GC0102 EU Connection Codes GB Implementation – Mod 3

Respondent:	<i>Greg Middleton</i>
Company Name:	<i>AMPS</i>
Please express your views regarding the Workgroup Consultation, including rationale. (Please include any issues, suggestions or queries)	<p><i>For reference, the Grid Code objectives are:</i></p> <ul style="list-style-type: none"> i. To permit the development, maintenance and operation of an efficient, coordinated and economical system for the transmission of electricity ii. To facilitate competition in the generation and supply of electricity (and without limiting the foregoing, to facilitate the national electricity transmission system being made available to persons authorised to supply or generate electricity on terms which neither prevent nor restrict competition in the supply or generation of electricity) iii. Subject to sub-paragraphs (i) and (ii), to promote the security and efficiency of the electricity generation, transmission and distribution systems in the national electricity transmission system operator area taken as a whole iv. To efficiently discharge the obligations imposed upon the licensee by this license and to comply with the Electricity Regulation

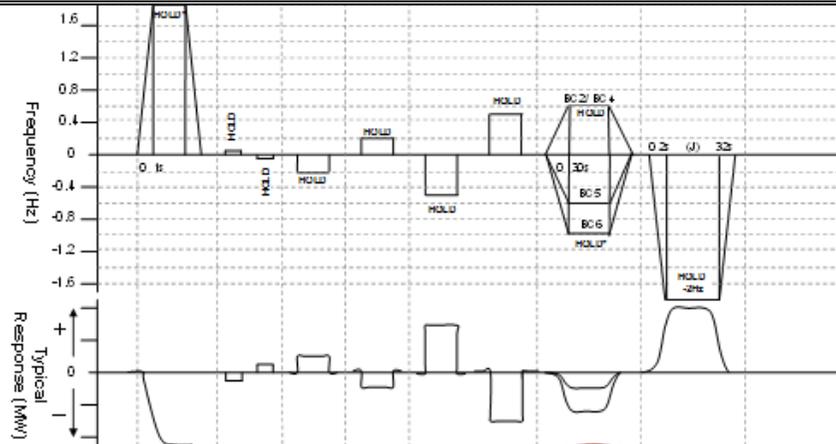
Comment [IG21]: remove injected signal as a ramp? during 10 sec? from experience some turbins manufacturers just remove the signal. This need to be clearer
